TO: Mayor Trey King, City of Dacula
ATTN TO: Brittini Nix, Director Planning and Economic Development, City of Dacula
FROM: Mike Alexander, Director, ARC Center for Livable Communities
RE: Development of Regional Impact (DRI) Review

Name of Proposal: Allora Dacula DRI 3750

Description: A DRI review of a proposal to construct a mixed-Use development with 378 multifamily units, 233 townhouse units, and 473,200 square feet of industrial space on a 103 acre off of Stanley Road in the City of Dacula in Gwinnett County.

DRI SITE PLAN

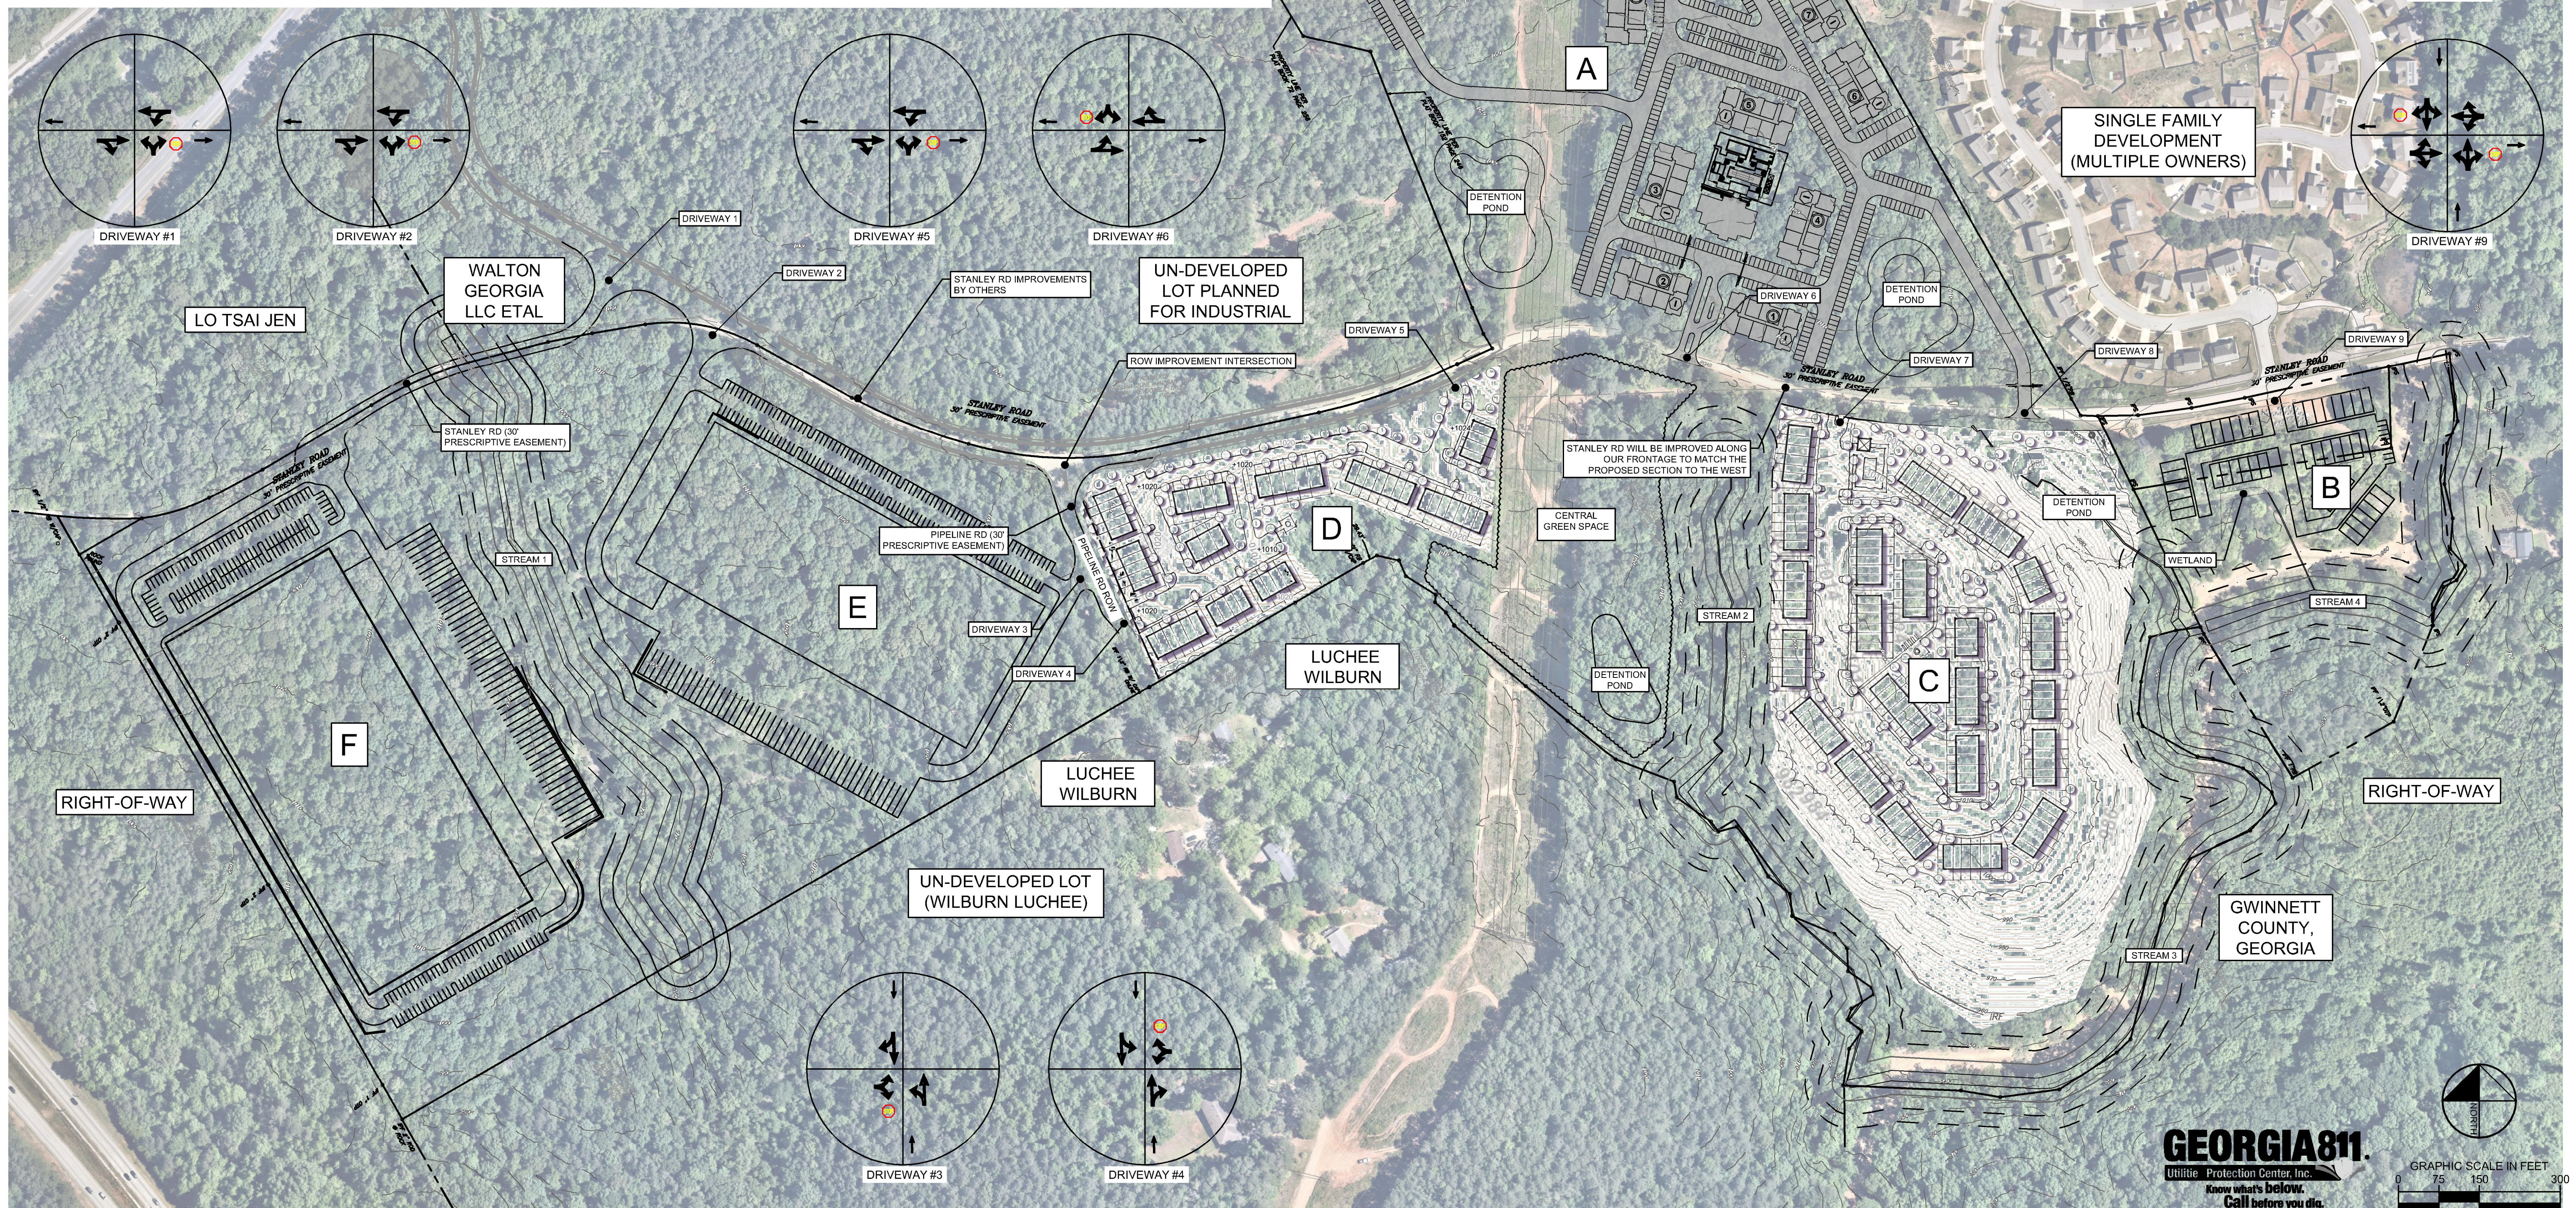
Incorporation of green stormwater and heat island mitigation designs for the roughly 1,102 surface car parking spaces proposed would be supportive of regional environmental policies.

The TIS notes that pedestrian facilities will be provided throughout the development but the location of these facilities is not apparent on the site plan; because of the size of the development, a hierarchy of pedestrian amenities, including a wider multi-use path connecting Parcels A, B, C, and D, with standard sidewalks within each Parcel, would support regional multi-modal transportation goals.

The TIS notes that pedestrian facilities will be provided throughout the development but the location of these facilities is not apparent on the site plan; because of the size of the development, a hierarchy of pedestrian amenities, including a wider multi-use path connecting Parcels A, B, C, and D, with standard sidewalks within each Parcel, would support regional multi-modal transportation goals.

The USGS coverage for the project area shows Hopkins Creek running along the eastern side of the project property and an unnamed intermittent stream running north to south through the western portion of the project. The submitted site plan shows both those streams and two other unnamed streams at the center and eastern side of the project property. Although not specifically identified, the site plan shows the 25-foot State Sediment and Erosion Control buffer as well as the 50-foot undisturbed buffer and additional 25-foot (total 75-foot) impervious surface setback required by the City of Dacula Stream Buffer Ordinance. No new intrusions (Stanley Road crosses two streams at the edge of the project property) into the buffers are shown on the submitted project plan
